CITY OF ALBUQUERQUE

August 27, 2018

**RE: L&C Transport Office and Shop
108 94th St NW
Grading and Drainage Plan
Engineer's Stamp Date 8/15/18
Hydrology File: K09D043**

By: WTB
GRADING & DRAINAGE PLAN
Sheet: Of:
C-100

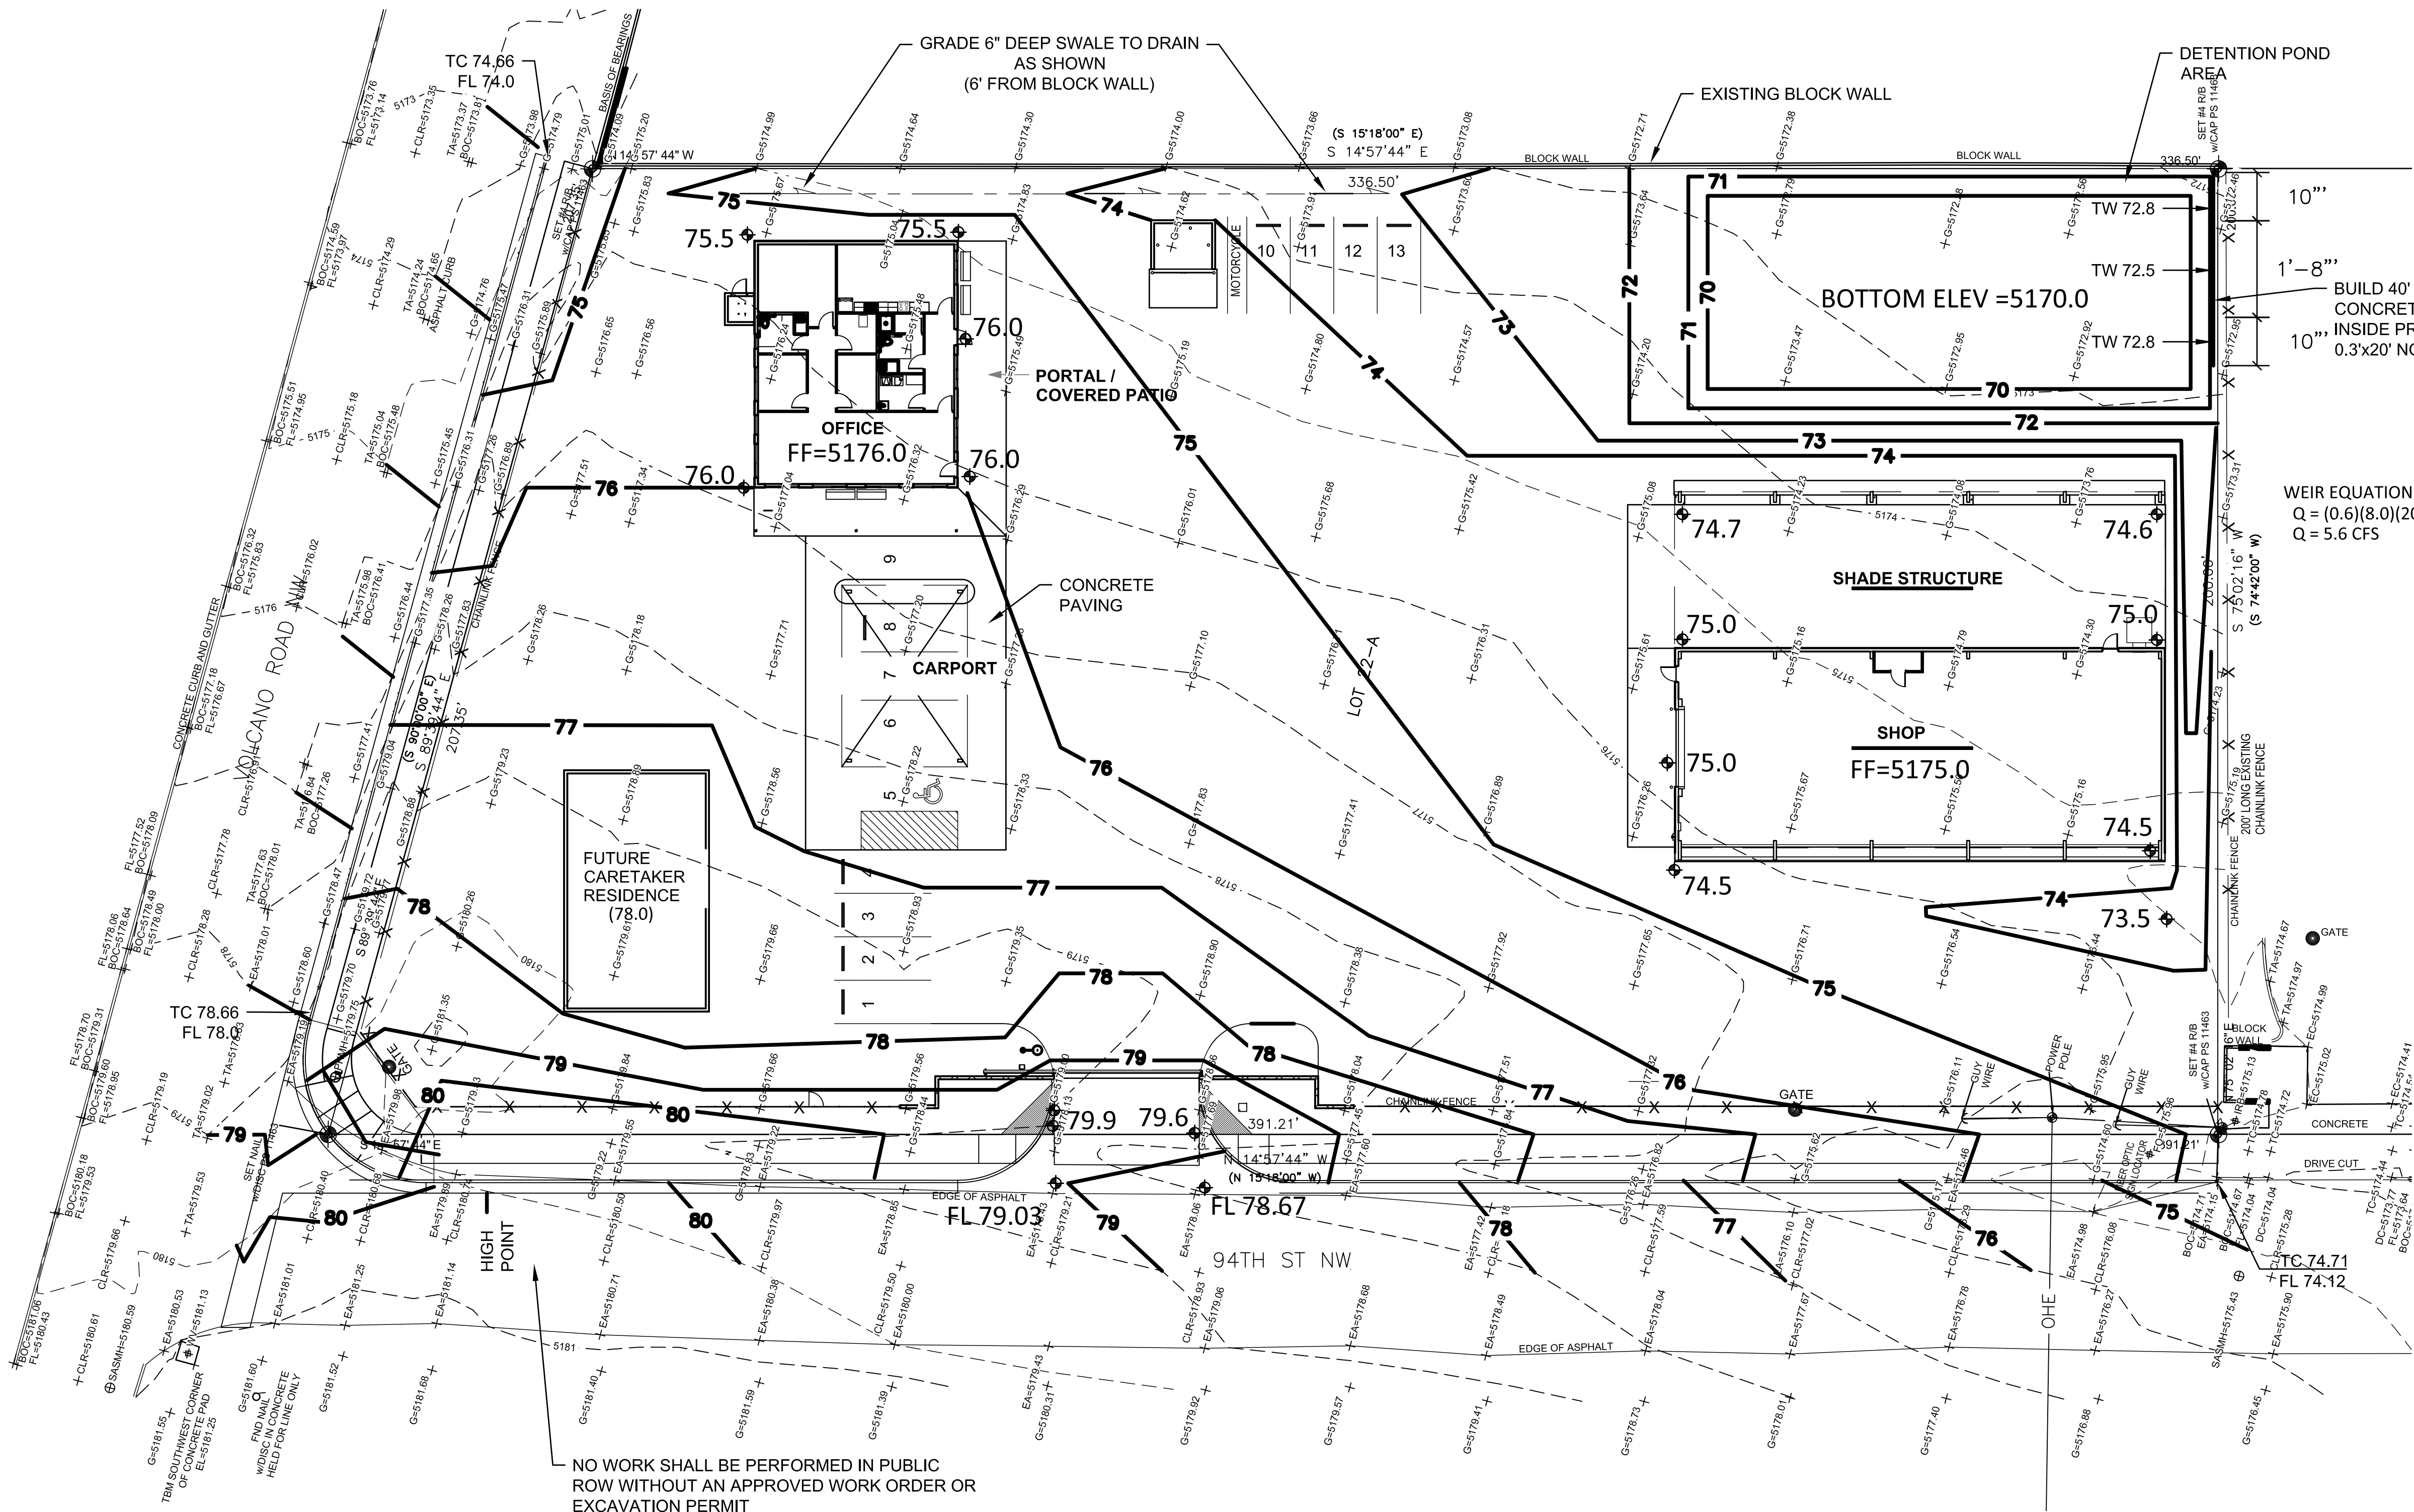
Based on the submittal received 8/17/18, the above referenced plan is approved for Building Permit.

Prior to Certificate of Occupancy (For Information):

1. The Drainage Covenant must be recorded with Bernalillo County and a copy included with the drainage certification.
2. City acceptance and close-out of the public Work Order will be required, unless a financial guarantee has been posted.
3. For Information. Hydrology and Transportation files are available online through the City's GIS Viewer 2.0: <https://www.cabq.gov/gis/advanced-map-viewer>. Turn on the *HydroTrans* layer: *Operational Layers > Albuquerque Layers > Sites > HydroTrans*. Select the desired polygon from the map and click *Link to Project Documents*.
